53 SILVERDALE GARDENS HAYES UB3 3LN

PLANNING RESPONSE

J79 STUDIO

FIG 1: Existing building and proposed extension width (refer to drawing A101)

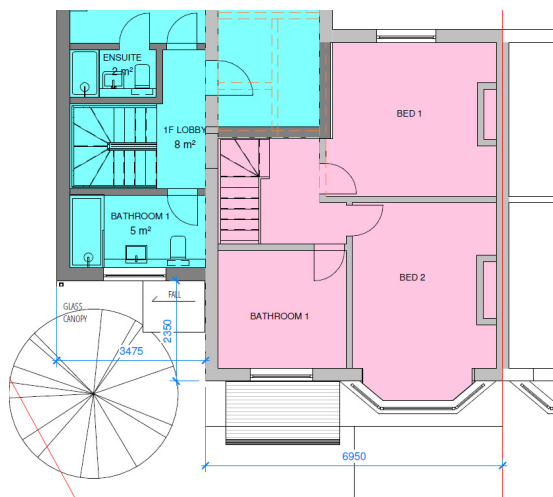
- 1 - The proposed part single storey, part two storey side and rear extension, by reason of its bulk, width and design would fail to form a subordinate addition to the host dwelling which harmonises with its original size and architectural composition. The proposed extension would therefore be detrimental to the character, appearance and visual amenities of the dwelling and street that the dwelling is part of. Therefore the proposal would be contrary to Policy BE1 of the Hillingdon Local Plan: Part One - Strategic Policies (November 2012), Policies DMHB 11, DMHB 12 and DMHD 1 of the Hillingdon Local Plan: Part Two - Development Management Policies (January 2020), as well as policies D3 and D6 of the London Plan and paragraphs 130 (a) and (c) of the NPPF (2021).

1.1 PROPOSED TWO STOREY EXTENSION WIDTH: Existing house width is 6.95m with side extension width being 3.5m which is half of the width of existing property (FIG 1).
